**PLANNING & DEVELOPMENT SERVICE
PLANNING DIVISION**

RE: Staff Memo – Initial Architecture and Site Review (IASR) for Lot 1004BR,
TBD Victoria Drive.

**APPLICATION OVERVIEW: New Single-Family Home on Lot
1004BR**

1 FIRE MITIGATION | TREE ANALYSIS PLAN
SCALE: 3/32" = 1'-0"

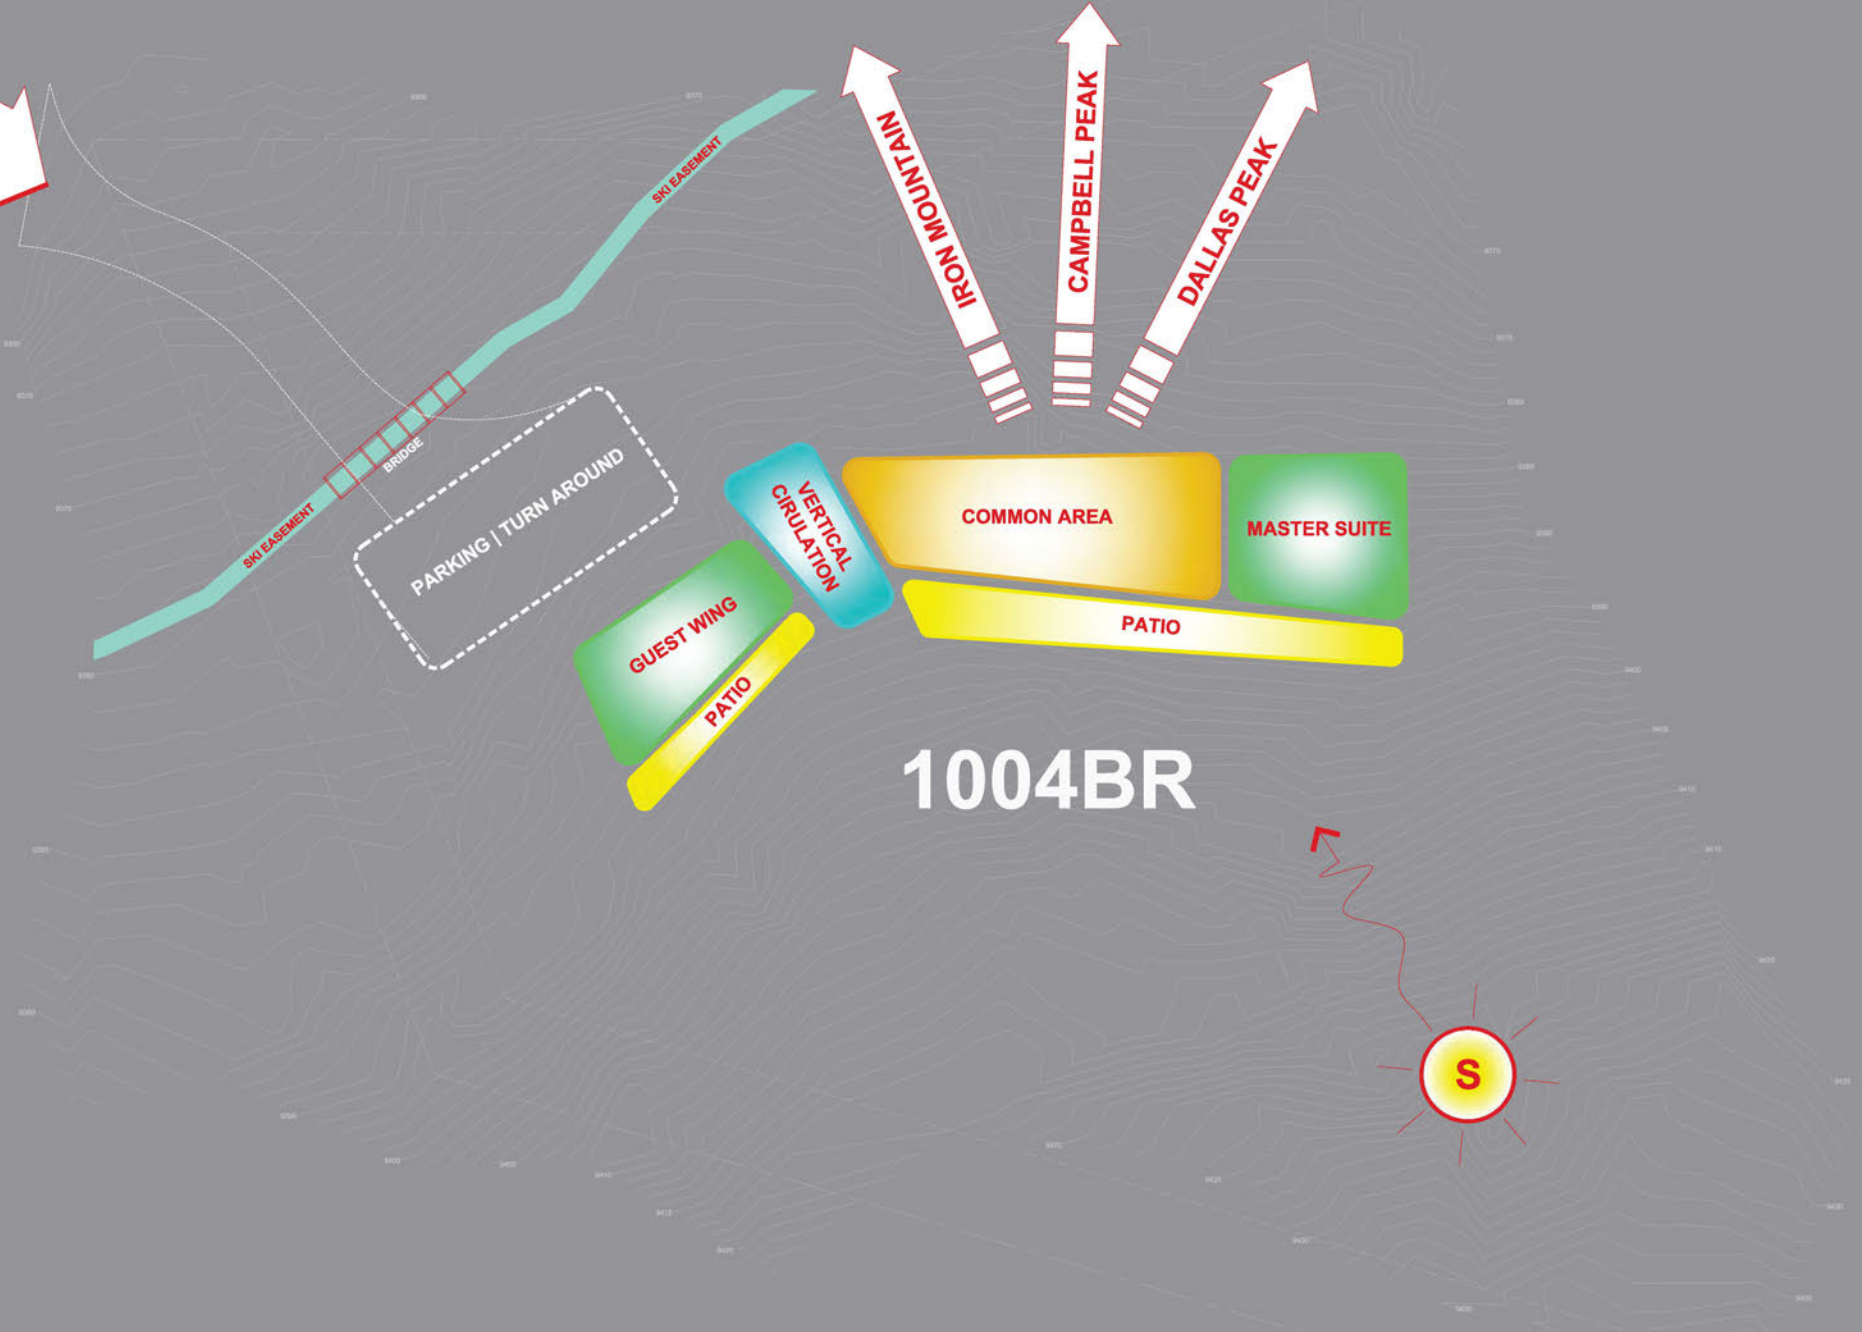
Staff: A fire mitigation plan was provided on Sheet C5. Additionally, an existing tree analysis was also provided on Sheet AT. The plans indicate several trees that are marked for retention that will need to be removed. Moreover, the site plan shows a garden with retaining walls that will also require the removal of trees for the construction of the retaining walls. The Fire mitigation plan shows several trees located on the zone 1 fire mitigation zone boundary that will need to be removed. Tree canopies may not encroach into the zone 1 boundary. Moreover, the fire mitigation plan shows grading limits along with zone 1 fire mitigation, and notes that all trees will be removed within the limits of grading. These trees are not shown on the tree analysis plan. The plans should be revised to match. The plan also needs to include scale bar to ensure that trees in zone 2 are complying with spacing requirements. The fire mitigation plan should be amended to reflect necessary tree removals prior to final review.

The site plans do not show a scale bar to indicate distances. Please include scale bar. In comparing the Fire Mitigation /Tree Analysis plan, there are trees indicated for retention that will have to be removed. The overall site plan shows a garden with retaining walls that will require the removal of trees for the construction of the retaining walls. Also, the Fire Mitigation/Tree Analysis plan shows tree trunks located directly on the 15-foot, zone 1 fire mitigation buffer boundary. Tree canopies may not encroach into the 15-foot fire mitigation buffer and will, therefore require these trees to be removed as well. Please correct the Fire Mitigation/Tree Analysis and Landscape plans to reflect these necessary tree removals.

A1.1 - SITE PLAN

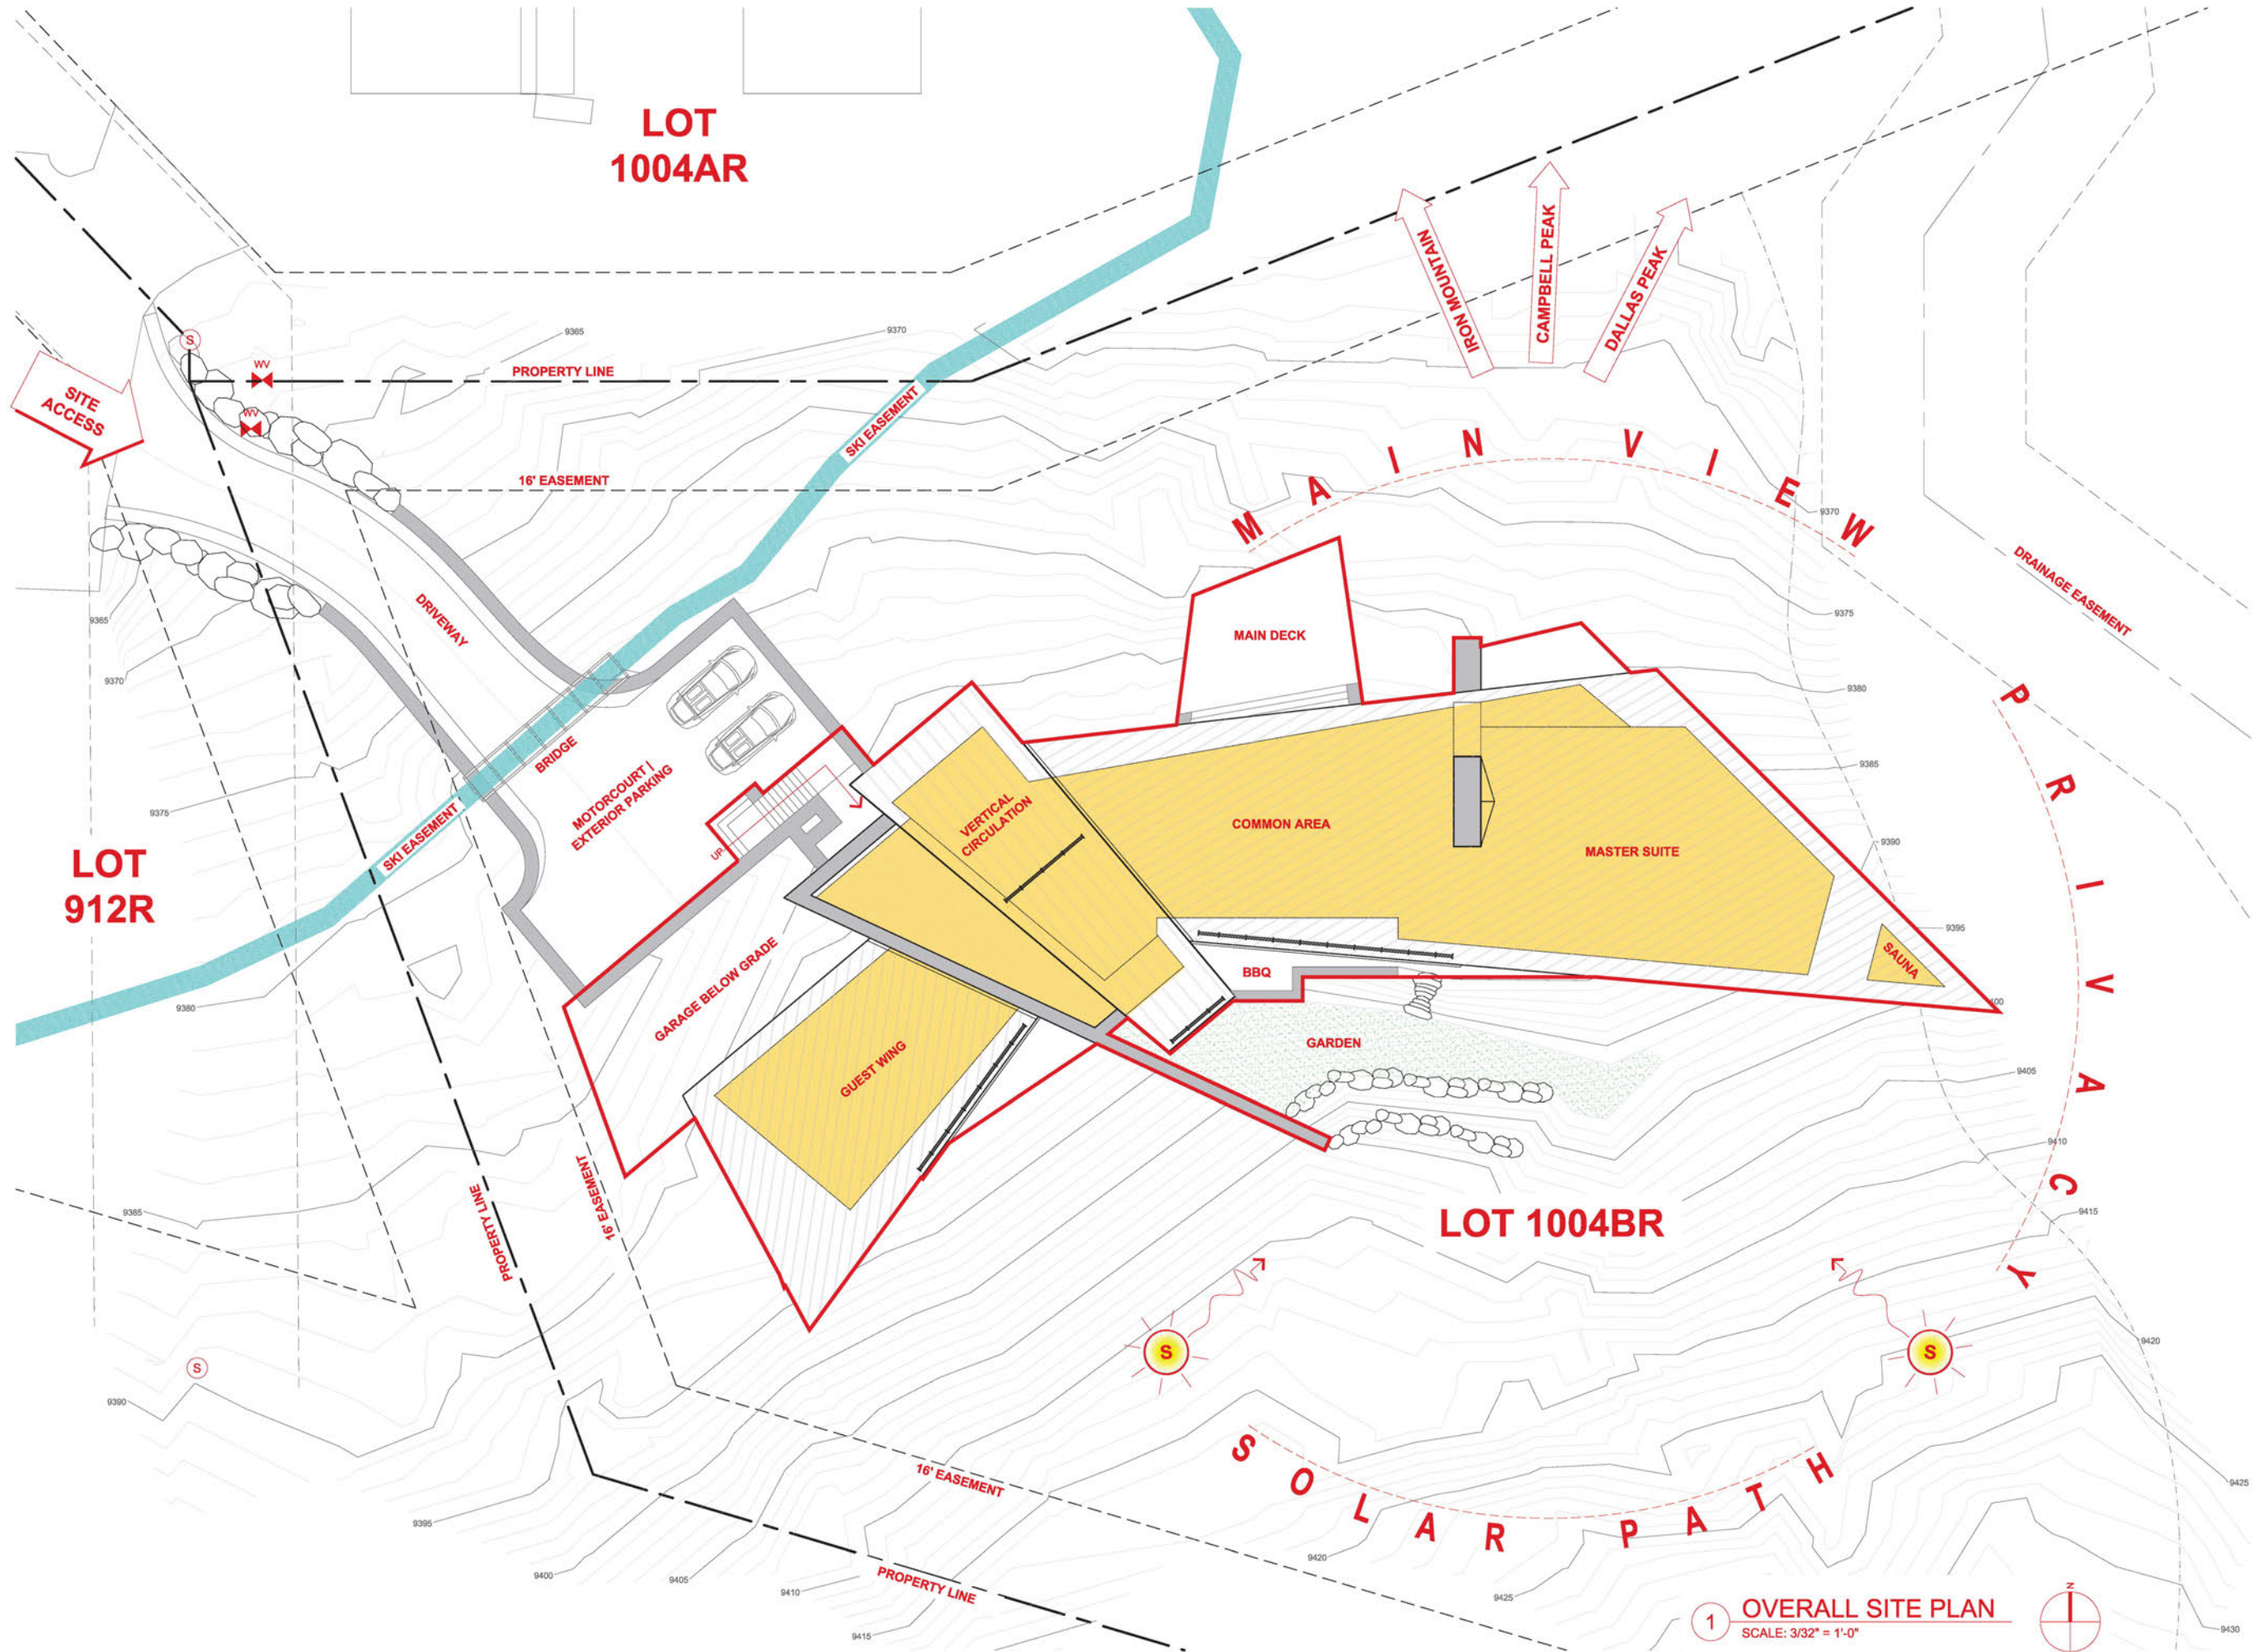
Staff: The applicant has shown four interior parking space and two exterior spaces on their architectural site plan. The four interior parking spaces are in a below grade garage. The garage door does not appear wide enough to accommodate spaces 1 and 4. Moreover, the dimensions of the parking spaces were not provided. The dimensions of the parking spaces and the garage entrance should be provided prior to final review.

- 1) Prior to final review, the applicant shall modify the landscaping and fire mitigation plans to adhere to the CDC and the Forester's comments.
- 2) Prior to final review, the applicant shall provide the dimensions of the parking spaces.

A1.2 - LANDSCAPE PLAN

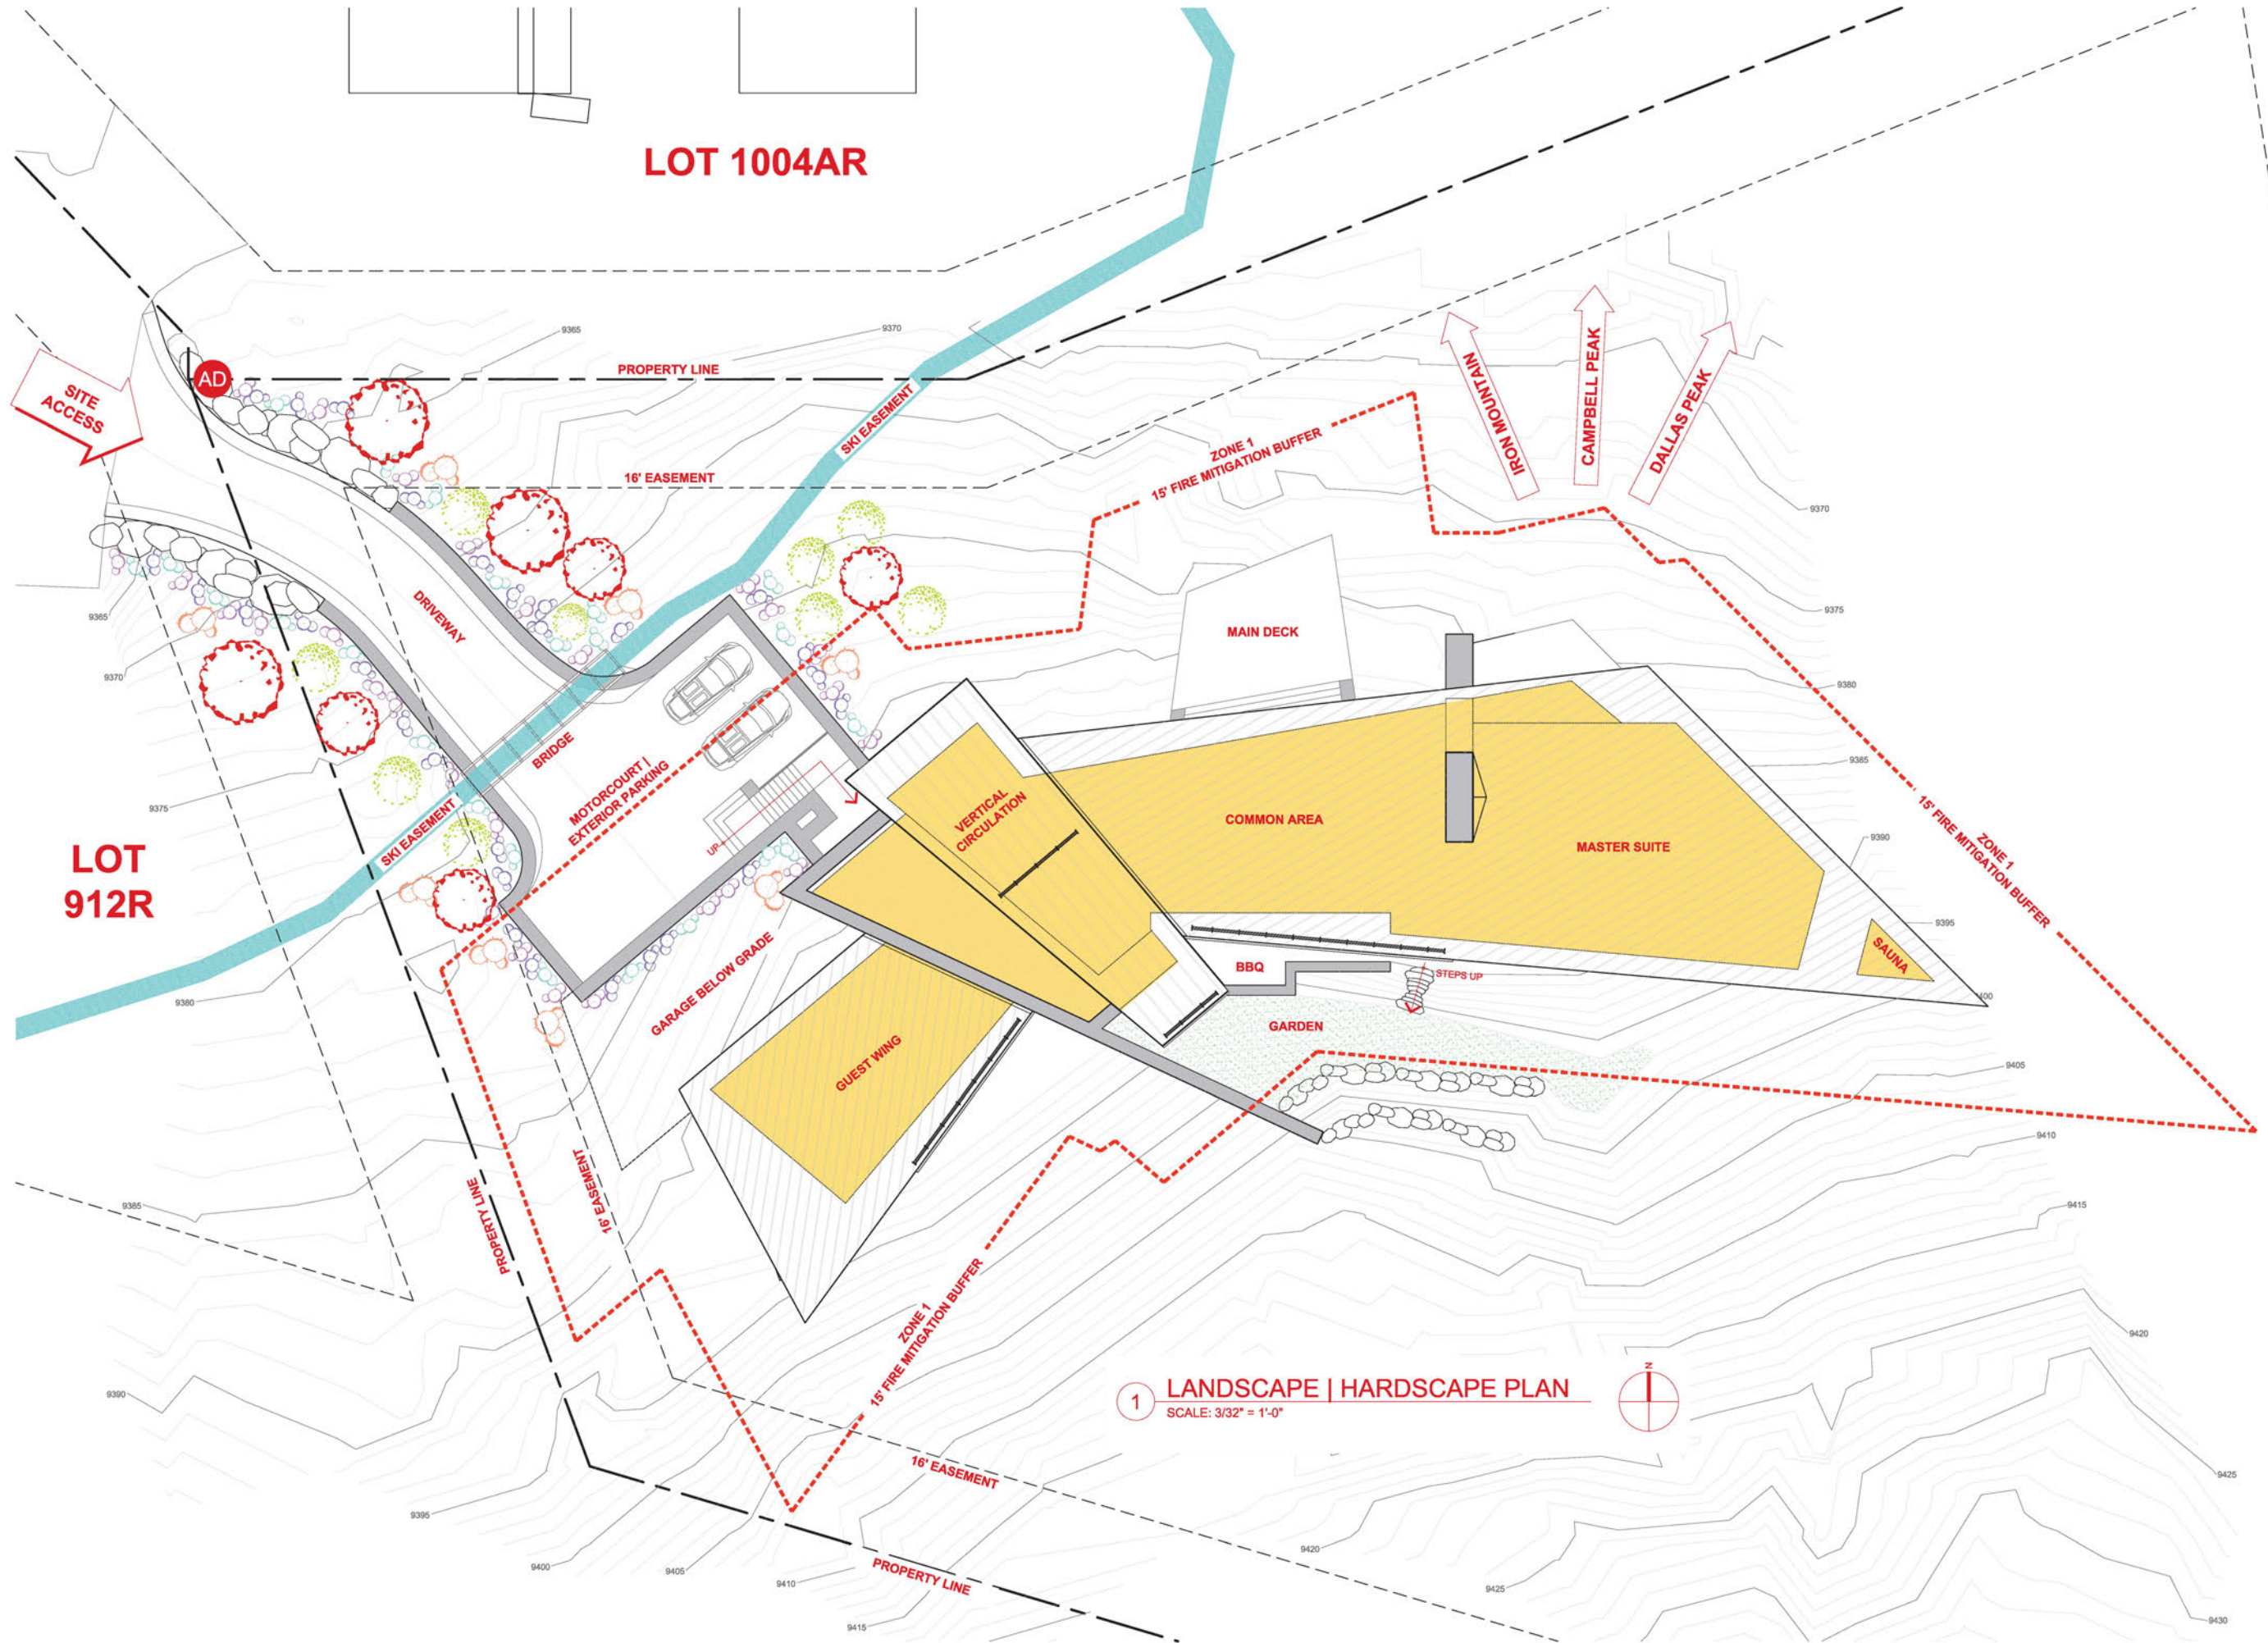
Staff: The applicant provided a landscape plan on Sheet A1.2. The site is heavily forested, and the development will require the removal of the majority of trees on the site. The plan proposes 7 Maple Trees, 9 Aspen, and several smaller plantings such as Jacob's ladder and Lavendar. The majority of the plantings are near the driveway. The plantings near the driveway will help soften the retaining walls at the front of the home. The plan also includes a garden at the back of the house. The garden currently includes alpine grasses. The applicant should clarify if other plantings are proposed in the garden. The landscape plan needs to be revised to include a scale bar. The plan should also contain a note to remove all strapping, wire, and burlap from at least the top 12 inches of the root ball. The plan also notes the use of cedar bark mulch. The Forester advises against the use of flammable mulch within the zone 1 wildfire mitigation boundary. Specify rock or other nonflammable mulch is recommended. Prior to final review, the landscape plan should be amended to address the Town Forester's comments.

Landscape notes need to contain a requirement to remove all strapping, wire, and burlap from at least the top 12 inches of the root ball (18 to 24 inches is better). Landscape plan states the use of cedar bark mulch. Flammable mulch is not recommended within the zone wildfire mitigation boundary. Instead, specify rock mulch or some other not flammable mulch material.
